Thank you,

To the 4FRI Team at the US Forest Service:

Please accept these comments from the Center for Biological Diversity ("the Center") on the Four Forests Restoration Initiative ("4FRI") Rim Country Draft Environmental Impact Statement ("DEIS"). These comments are the culmination of years of very active involvement in the 4FRI effort. The Center has maintained a leading role in the 4FRI Stakeholders Group, and has engaged in a wide range of collaborative discussions with Stakeholders and the Forest Service. We intend to continue engaging in the deepest levels possible through the remainder of the planning process, and into the implementation of the Rim Country Project.

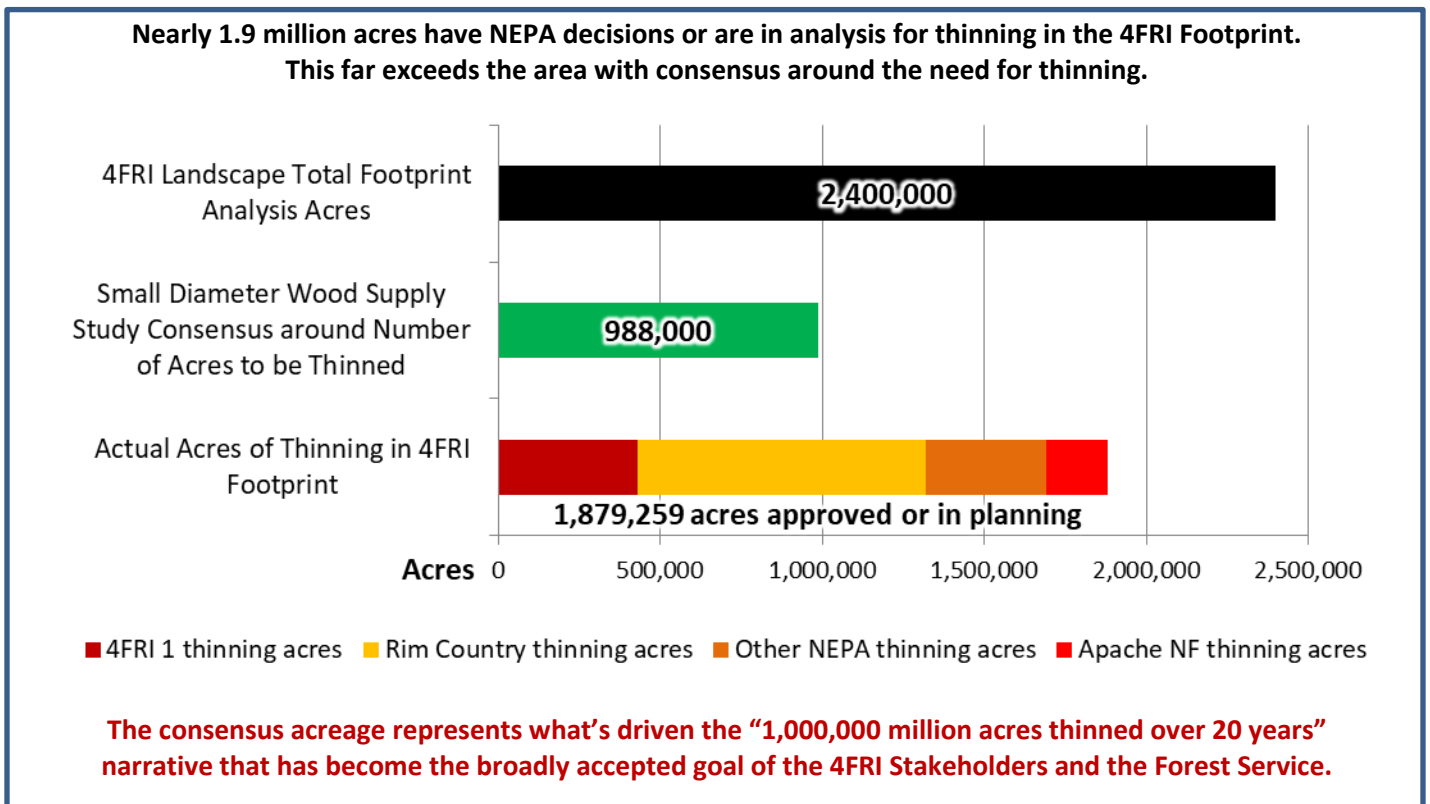
“[a]pproximately 255,249 acres have been removed from this silvicultural analysis because they are part of an ongoing project or are being analyzed in a separate analysis,” “[a]pproximately 30,263 acres are either non National Forest System lands, or are non-forested,” and “[a]n additional 1,141 of these acres identified as “Other” in Table 4 were determined to be either surface water, mineral pits, dams or road surface and will not be given a detailed description in this silvicultural analysis.”<sup>96</sup> The DEIS then says that “[t]he remaining 951,691 acres, considered the analysis area, will be analyzed in this report.” As an initial matter, the Forest Service has provided an inaccurate reporting as these numbers simply don’t add up. But more importantly, if the area available for mechanical treatments by way of this process of elimination is 951,691 acres (or 952,005, depending on who’s math you trust), and the area reported in the DEIS as receiving mechanical treatment is 889,340 acres, then the preferred alternative assigns mechanical treatments to a whopping 93% of the analysis area.

- Approximately 255,249 acres have been removed from this silvicultural analysis because they are part of an ongoing project or are being analyzed in a separate analysis (Figure 3). Silvicultural treatments and their effects within these areas will not be analyzed in this report.
- Approximately 30,263 acres are either non National Forest System lands, or are non-forested.
- An additional 1,141 of these acres identified as “Other” in Table 4 were determined to be either surface water, mineral pits, dams or road surface and will not be given a detailed description in this silvicultural analysis.
- The remaining 951,691 acres, considered the analysis area, will be analyzed in this report.

Shown above: Page 136 of the DEIS provides inaccurate accounting as these numbers do not add up.

**Figure 28. Alternative 2 - Proposed Action – Percent of acres meeting desired condition for basal area across the analysis area.**

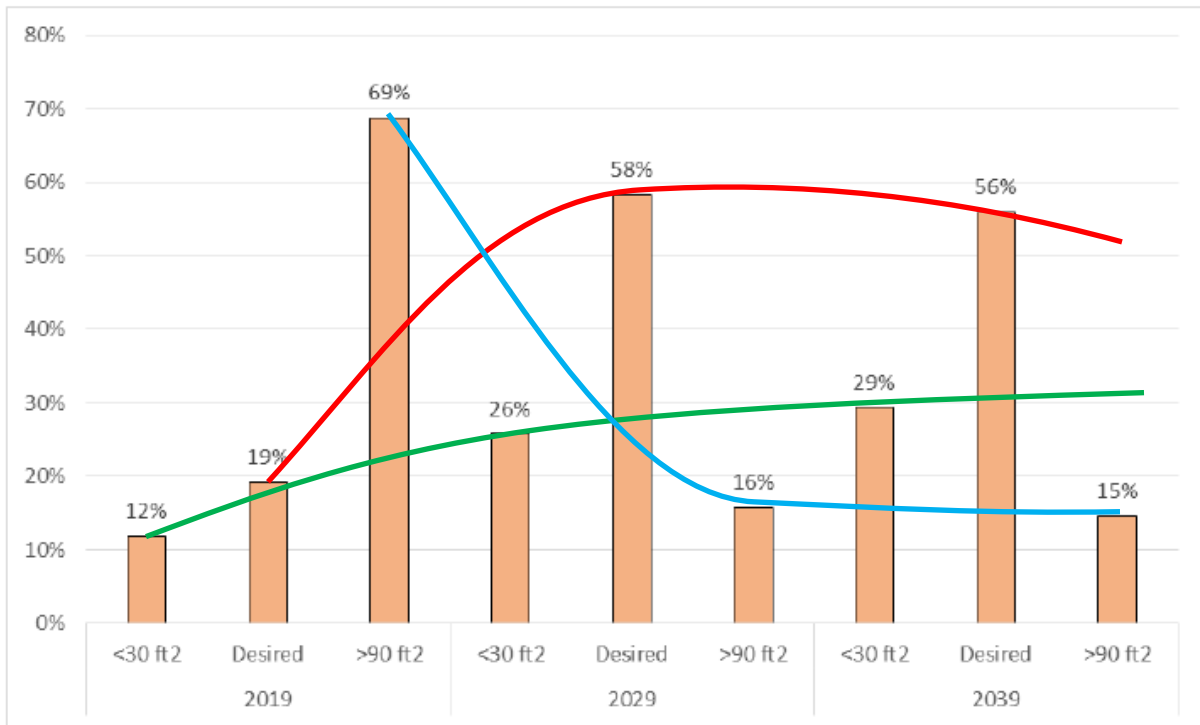
Figure 28<sup>104</sup> shows that the proposed action treats the landscape too intensively, with basal area dipping below the stated desired conditions range of 30-90 ft<sup>2</sup> BA in 26% of acres in 2029 and increasing to 29% of acres below desired conditions in 2039. We have plotted generic trend lines onto Fig. 28 to show this. Collectively, with 275,990 acres below desired conditions in 2039, these trends suggest that treatments are too intense, and conflict with the statement that “[t]he number of trees per acre, basal area, and SDI would decrease considerably, trending toward desired conditions within NRV ....”<sup>105</sup>

The **red line** shows a large growth of the portion of the landscape that meets desired conditions by 2029, but then trending away, with 56% of the landscape between 30 and 90 ft<sup>2</sup> BA by 2039. The reduction in acres meeting desired conditions is driven more by growth of acres below 30 ft<sup>2</sup> BA than above 90 ft<sup>2</sup> BA.

The **blue line** shows a major reduction by 2029 in the portion of the landscape that is above desired conditions, followed by a plateau, with 15% of the landscape above 90 ft<sup>2</sup> BA by 2039, a minor decrease from 2029.

**RECOMMENDATION:** Any subsequent NEPA document prepared for the Rim Country analysis should illustrate and report on modelling results in a manner that does not portray modelled acreage above 90 ft<sup>2</sup>/acre basal area as “above desired conditions” if those acres are located in wildlife or vegetation strata that have desired conditions above 90 ft<sup>2</sup>/acre as described in applicable planning documents.

**Figure 29. Alternative 2 - Proposed Action – Percent of stands meeting the desired condition for stand density index**

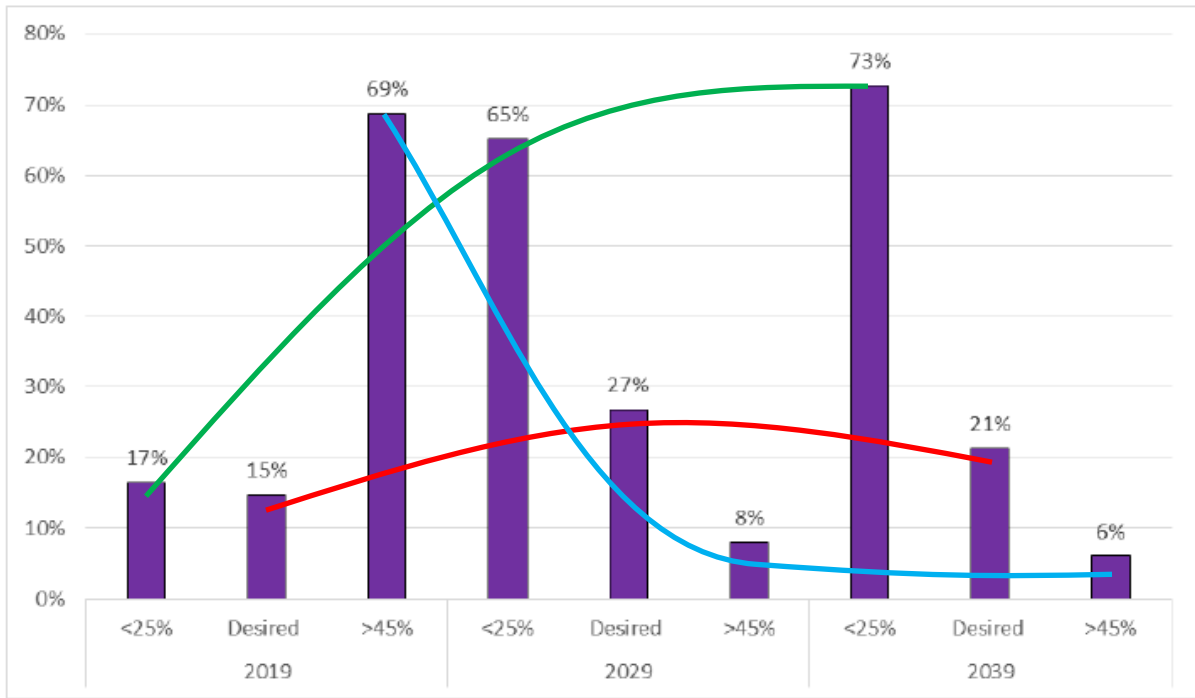
Figure 29<sup>119</sup> shows that the proposed action treats the landscape too intensively, with SDI dipping below the stated desired conditions range of 25-45% of SDI Max in 65% of acres in 2029 and increasing to 73% of acres below desired conditions in 2039. We have plotted generic trend lines onto Fig. 29 to show this. Collectively, with 694,734 acres below desired conditions in 2039, these trends suggest that treatments are too intense, and conflict with the statement that “[t]he number of trees per acre, basal area, and SDI would decrease considerably, trending toward desired conditions within NRV ...”<sup>120</sup>

The **red line** shows a minor growth in the portion of the landscape that meets desired conditions by 2029, but then trending away, with just 21% of the landscape between 25% and 45% of SDI Max by 2039. The reduction in acres meeting desired conditions is driven primarily by growth of acres below 25% of SDI Max.

The **blue line** shows a major reduction by 2029 in the portion of the landscape that is above desired conditions, followed by a slight downward trend, with 6% of the landscape above 45% of SDI Max by 2039, a minor decrease from 2029. The continued decrease of area above desired conditions is driven by growth in the area below desired conditions.

Figure 46. Percent of annual large fires burned by severity class

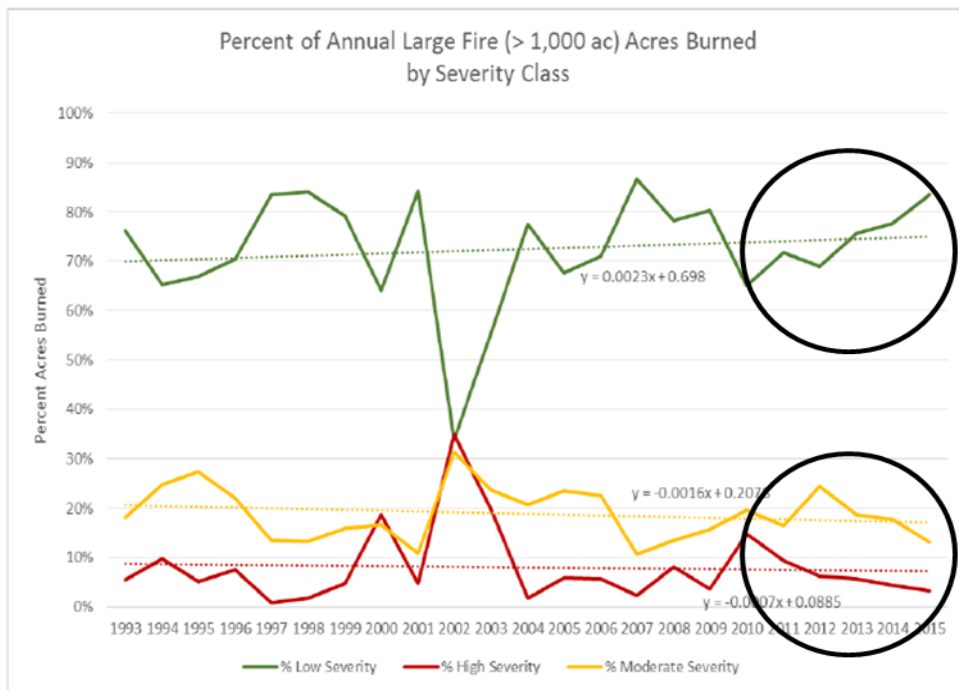
Figure 46<sup>161</sup> is as compelling of a chart as one could see, clearly illustrating that the vast majority of the fires since 1993 have burned at low severity. While the narrative doesn’t explicitly say, it appears that the statement that “[o]f the annual acres burned by large fires since 1992, about 73 percent burned at low severity on average, and 27 percent burned at moderate to high severity”<sup>162</sup> is a description of Figure 46. As the DEIS states, “it is primarily those areas that burn with uncharacteristic severity that are of concern,”<sup>163</sup> so we wonder why the Forest Service seems intent on telling a narrative that the system is so far out of balance?

The current condition and trend, as displayed in Figure 46, is not very far from Rim Country’s stated desired conditions, which are “for no more than 15 percent of the ponderosa pine (under conditions modeled) in the treatment area to be prone to crown fire or high-severity fire, with areas of potential high severity spatially distributed. For the dry mixed conifer cover type, Forest Plan direction is to allow fire to play its natural role, with high frequency (averaging about 12 years) and mostly low severity (less than 20 percent high severity under modeled conditions).”<sup>164</sup> The values reported in Table 29 reinforces this. For example, Table 29 states that in Dry Mixed Conifer, the desired condition is for less than 20% of acres to burn at high severity and recent fires have burned at 19% high severity.<sup>165</sup> And even two recent Rim Country suppressed fires that burned with undesirable impacts on human life and property were within desired conditions for fire severity (2017 Highline fire was 18% high severity) or just over desired conditions (2018 Tinder Fire was 27% high severity).<sup>166</sup>

Of added significance are the trends shown in Figure 46, with fires burning at increasingly more proportion of low intensity, and decreasing in proportion of moderate and high severity. This data, made clear in graphical form, contrasts with the claim in the DEIS that “[c]urrent conditions inhibit the survival and recruitment of large trees by fueling **increasingly extensive high severity fires.**”<sup>167</sup> If it’s true that “[c]onditions across 80% of the project area would be capable of supporting active or passive crown fire under extreme fire weather conditions,”<sup>168</sup> then why don’t actual observations of actual fires over the past 25+ years support that modelling result? And even after fulfilling the thinning and burning

The DEIS states that “[o]verall, the annual acres burned by large fires has increased since 1992 (Figure 45), while the proportion of acres burned in each severity class has remained about the same (Figure 46). If these patterns continue into the near future (10 years), the total acres of high severity fire is likely to increase proportional to fire size increases.”<sup>170</sup>

We strongly contest the conclusions drawn in this statement. The pattern over the past 28 years is clearly a reduction in moderate and high severity fire proportions and an increase in low severity proportions (again, refer to Figure 46). This contrasts with the claim that proportions have stayed the same. Furthermore, if the past decade is precedent to the next decade, things look even better. An estimate of severity trends as shown in the black circled areas on Figure 46 below suggest that the past decade has seen a roughly 20% increase in areas burned at low severity, while moderate and high severity decreased by the same amount.
